Subject: Determination Letter on Variance request from design standards Sections 13.4.2, 18C.7.4.4 & 18C.7.4.6, 18C.7.7 and 18C.10.6

Re: Wastewater Collection and Treatment System Project,
DNR Project No. S2008-0208
Ringgold County, IA

VARIANCE REQUEST
Iowa Department of Natural Resources

Re: Wastewater Treatment System – Variance Request
SW Ringgold County Iowa
Southern Iowa Rural Water Association
G&A 3007055

**WASTEWATER SYSTEM
FLOW DIAGRAM**

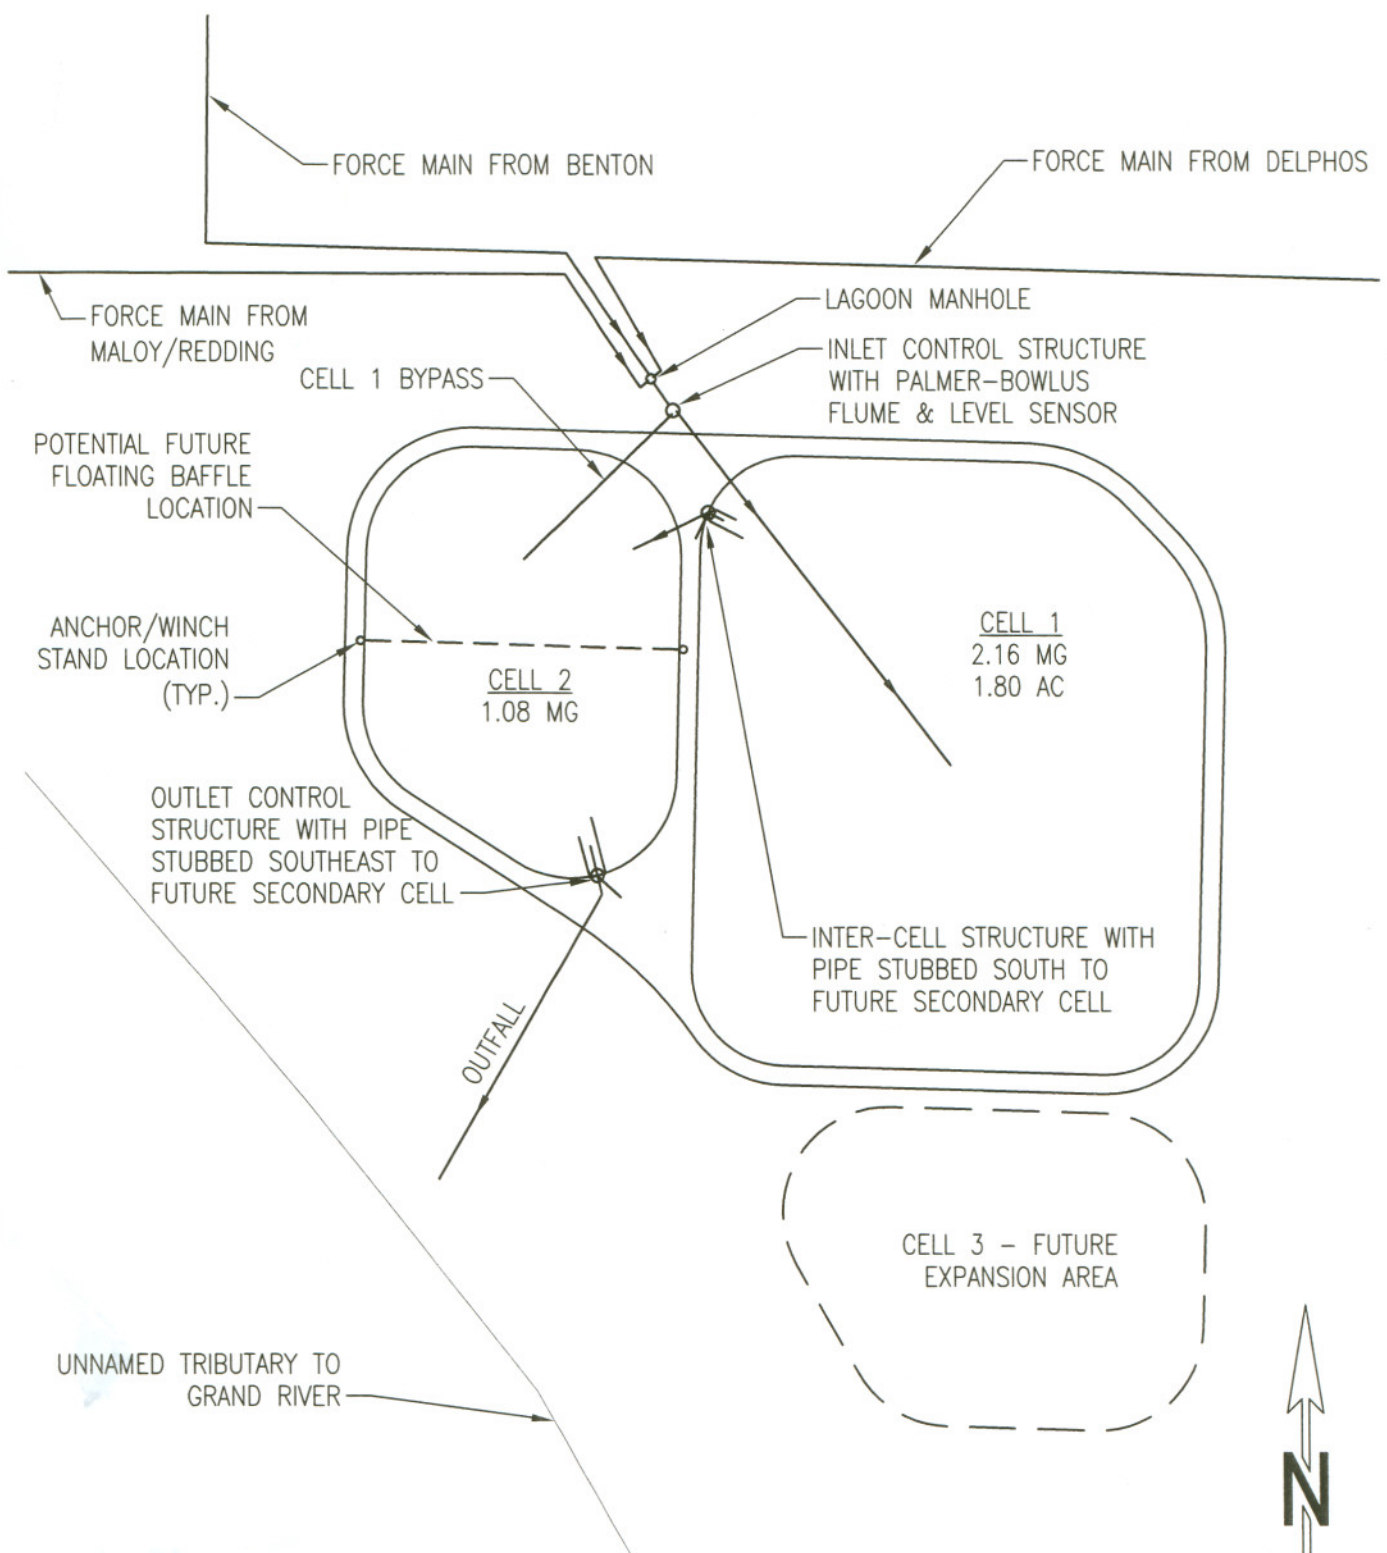
- B. Chapter 18C.5.1.2 – Allow the SW Ringgold controlled discharge pond system to consist of two cells.
- C. Chapter 18C.7.4.4 – Allow the influent line for controlled discharge ponds for SW Ringgold to be located on top of the pond liner; constructed of ductile iron pipe; suitably anchored.

- D. Chapter 18C.7.4.6 – Allow the influent lines to discharge horizontally at the level of the pond liner for SW Ringgold.
- E. Chapter 18C.7.7 – Allow SIRWA to prefill the SW Ringgold ponds to the one foot level due to very limited availability of water.

- F. Chapter 18C.10.6 – Allow SIRWA to utilize riser piping buried adjacent to control structures to measure pond level in lieu of calibrated mast or other level measuring device installed in the pond.

Variance Items C and D are requested based on the facts that piping installed on top of the lagoon liner and without inlet depressions can be constructed at lower costs and in areas where groundwater and soil conditions could prove to be challenging. Elimination of the inlet depressions and buried piping will allow the lagoon liner to be constructed at a higher elevation. We believe that the liner has better integrity without piping installed below the floor. We do not know of any problems that have developed as a result of installing ductile iron pipe, properly anchored, without an inlet depression; and the lagoons can be maintained during the long term. It is our opinion that the initial construction cost and potential construction challenges maintaining separation with groundwater and challenges associated with potential additional overexcavation, will cause undue and unnecessary hardship.

Variance Item F is an alternative method of accomplishing pond level measurements which will not be susceptible to ice damage or lagoon level gauge movement. Buried riser piping located adjacent to control structures is the lagoon level measuring technique utilized in many lagoons throughout the state; we are aware of no problems related to this practice and believe that pond level measurement is more accurately and reliably accomplished with use of buried piping and staff gauge. It is our opinion that the initial construction cost and ongoing maintenance costs associated with lagoon level measuring devices located within the pond will cause undue and unnecessary hardship; measuring the lagoon level in piping provides equivalent effectiveness.

Decision: **Approved with conditions.**

- a. Ductile iron pipe shall be used.
 - b. The influent line shall rest on a suitable concrete apron which is large enough such that the terminal influent velocity at the end of apron does not cause soil erosion as required by Iowa Wastewater Facilities Design Standards Section 18C.7.4.6. The apron must have a lip or baffle at the opposite end of the discharge point.
 - c. Adequate measures must be taken to ensure that the line is properly secured and anchored.
3. **Variance for pond level gauge:** The requested variance is to allow utilizing riser pipe buried adjacent to the control structures to measure the pond level in lieu of pond level gauges installed in the ponds as required by the Iowa Wastewater Facilities Design Standard 18C.10.6.

Decision: **Approved with conditions.**

- The pond level measurement arrangement shall allow for independent depth measurement of each cell.
4. **Variance for prefilling:** Iowa Wastewater Facilities Design Standards Section 18C.7.7 requires all controlled discharge lagoons to be prefilled to the two foot level, where water is available, to protect lagoon liner, to prevent weed growth, to encourage rapid start up the biological process and discourage odor. The requested variance is to allow prefill to the one foot level.
